MANHATTAN COMMUNITY BOARD FOUR

April 9, 2021 Sarah Carroll, Chair Landmarks Preservation Commission David N. Dinkins Municipal Building, 9th Floor North 1 Centre Street New York, NY 10007

Re: Rooftop Generator Proposal, Starrett-Lehigh Building, 601 West 26th Street, Manhattan

West 28th and 11th Avenue

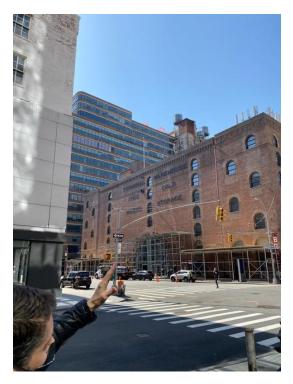
The applicant constructed a mockup of the envelope for proposed rooftop equipment. Our review of this rooftop mockup finds that the proposed construction would be clearly visible from both north and south; see photos of views from Eleventh Avenue at West 28th and West 29th Streets; Eleventh Avenue between West 29th and 30th Streets between Eleventh and Twelfth; and West 24th Street between Eleventh and Twelfth Avenues. The mockup can also been seen from the West Side Highway, the High Line, and the Hudson River Park. This visibility would not be mitigated by a background of roof bulkheads or taller neighboring buildings; it would unacceptably detract from the building's originally intended fluid skyline.
